Re: Former Signal Oil Marine Storage and Distribution Facility
(Former Chevron Bulk Plant 20-6127)
2301-2311 Blanding Avenue
Alameda, California
LOP Case RO0002466

Re: Addendum to Work Plan for Additional Site Investigation
Former Signal Oil Marine Storage and Distribution Facility
(Former Chevron Bulk Plant 20-6127)
2301-2311 Blanding Avenue
Alameda, California
LOP Case RO0002466

Subject: SLIC Case No. RO0002466 and Geotracker Global ID T06019744728, Park Street Landing
2301-2337 Blanding Avenue, Alameda, CA 94501

figure 1
SITE PLAN
CHEVRON 20-6127 - FORMER SIGNAL OIL BULK PLANT
2301-2311 BLANDING AVENUE
Alameda, California

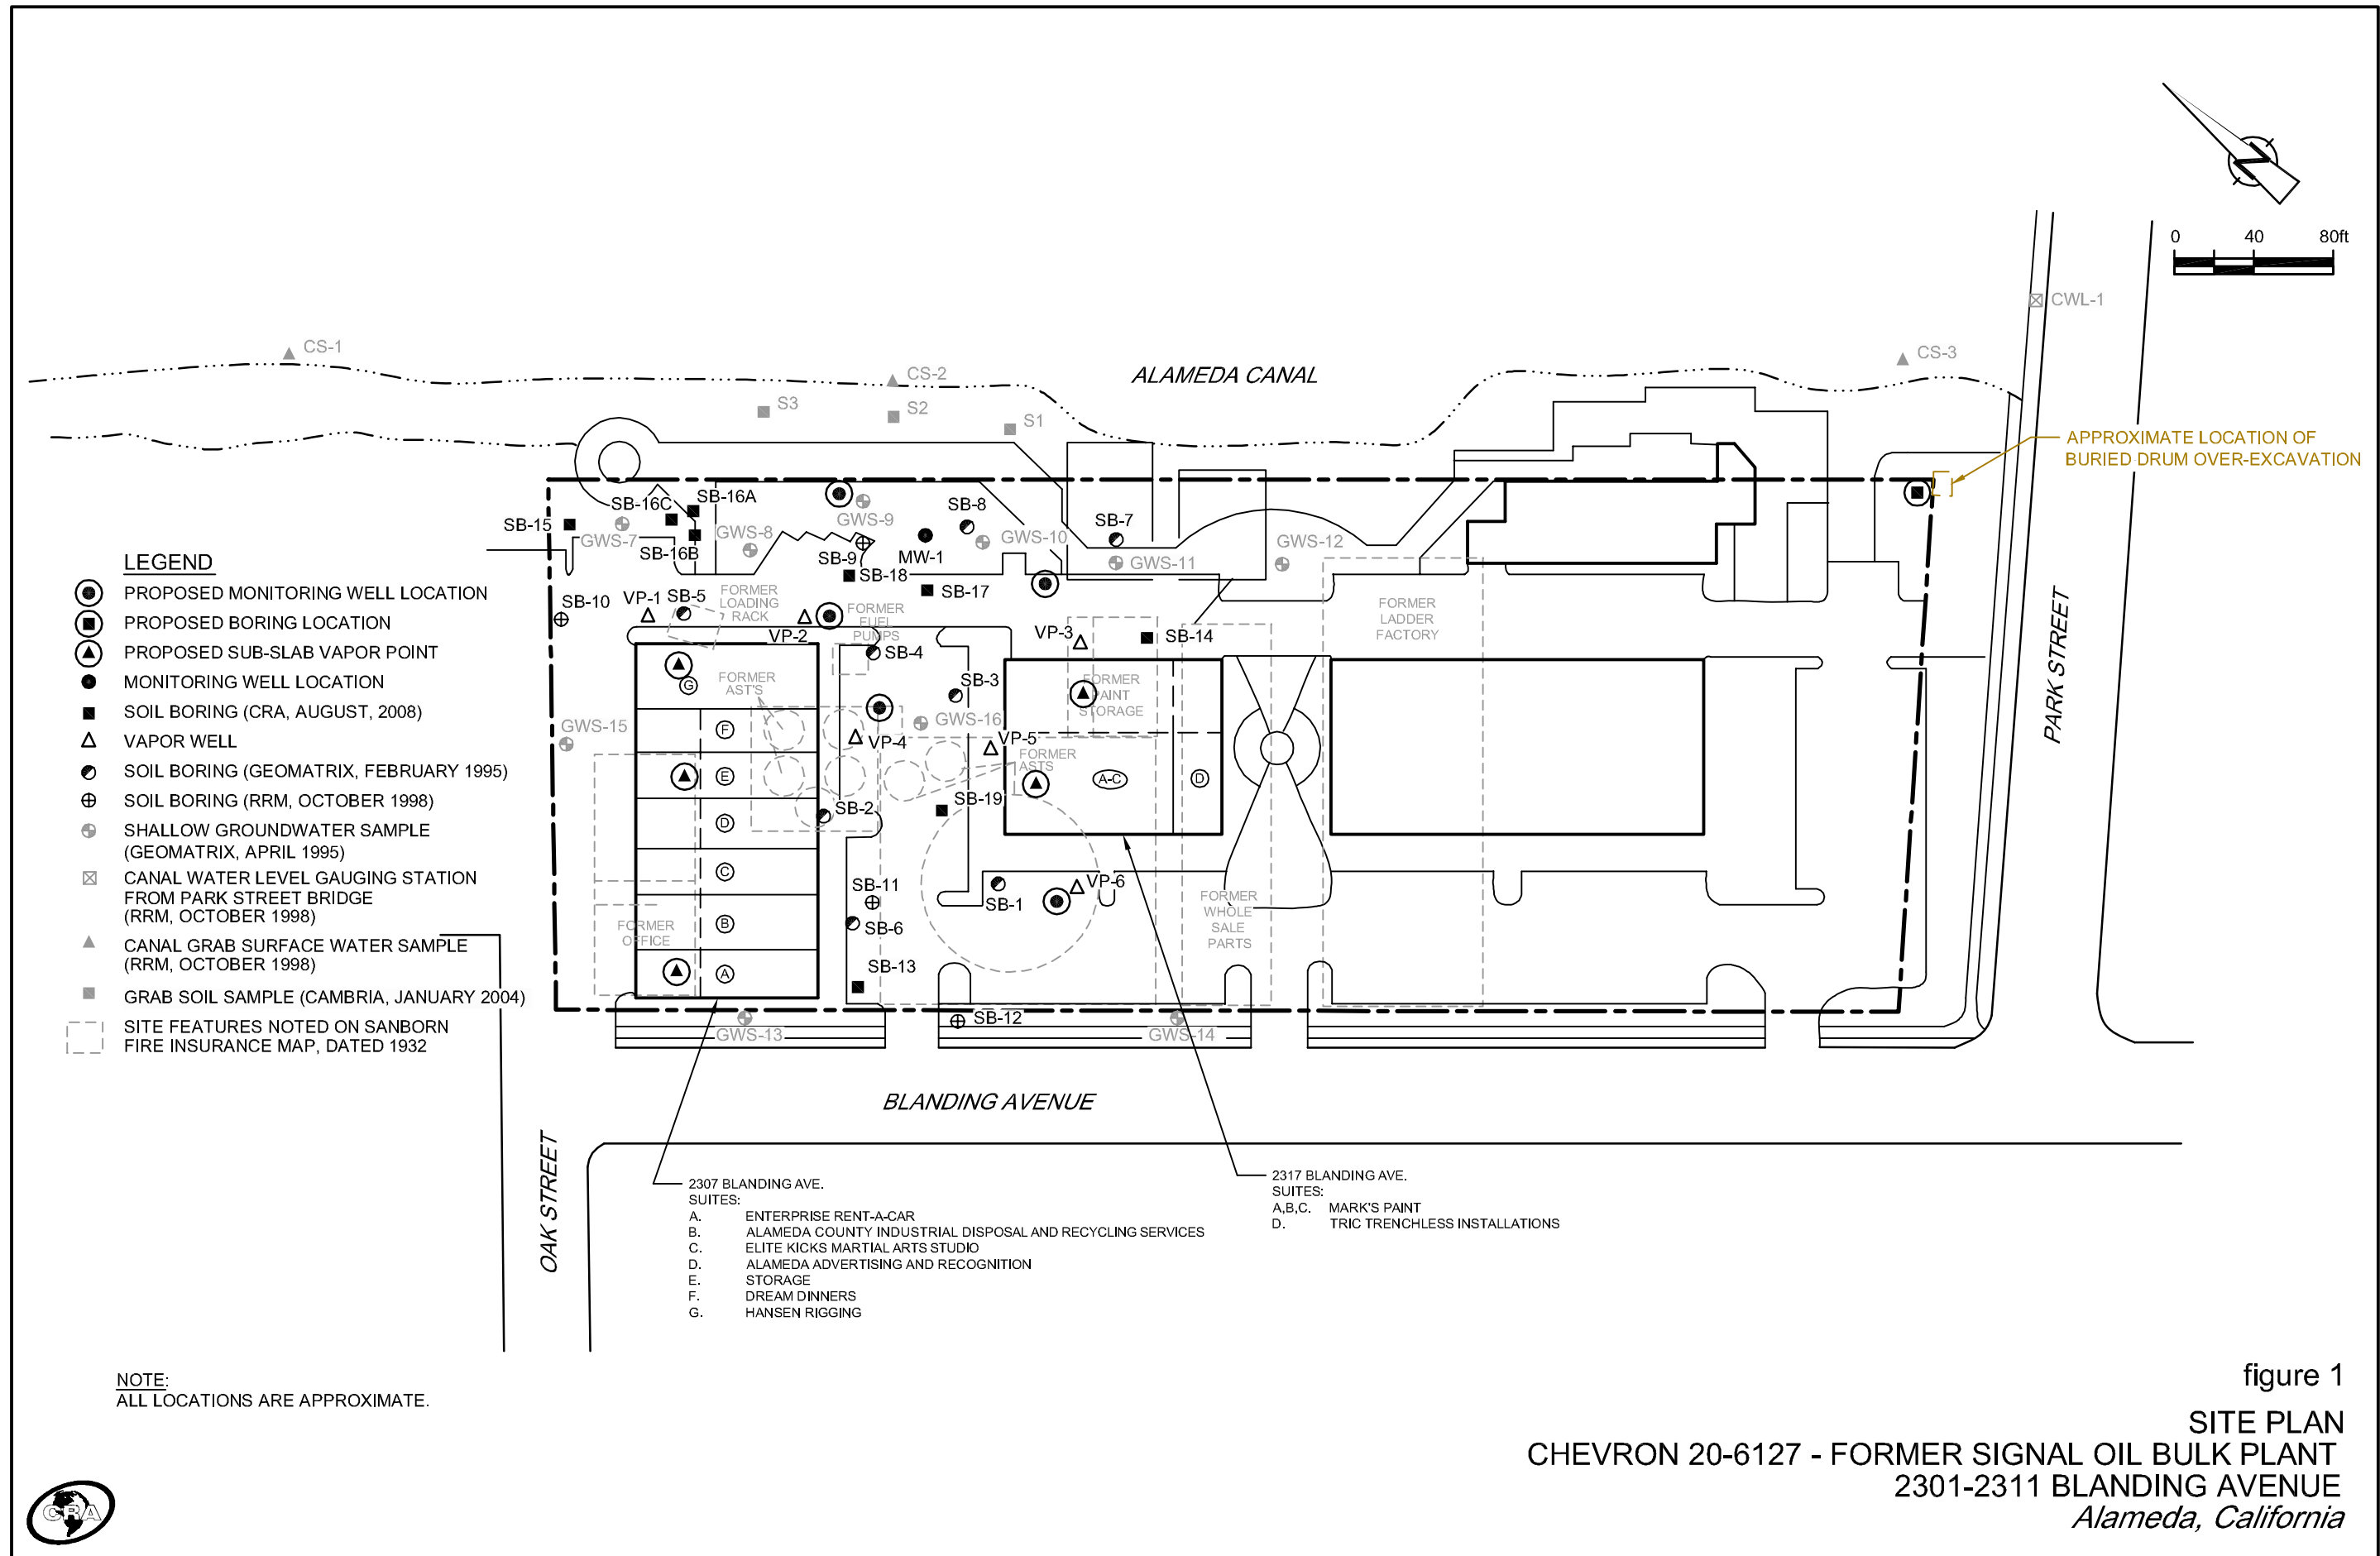
1. **Sub-Slab Sampling Locations.** The proposal to conduct sub-slab soil vapor sampling in the two northwestern buildings on the site is generally acceptable. The Work Plan indicates that the locations and numbers of sub-slab sampling points will be provided to ACEH after access agreements are completed. Please provide the proposed sub-slab sampling locations in a Work Plan Addendum no later than May 29, 2009.

Based on discussions with the property lessee, building layout, and individual tenant layouts within each suite, CRA proposes to install three sub-slab sampling probes in 2307 Blanding Avenue (Suites A, E, and G) and two sub-slab sampling probes at 2317 Blanding Avenue (Suite A-C). The proposed locations are shown on the attached Figure 1. The proposed probe locations are located in storage/warehouse portions of the suites to minimize the impact on each business during probe installation, sampling and decommissioning, and to minimize the need to remove/repair carpet or other flooring present in the suites.
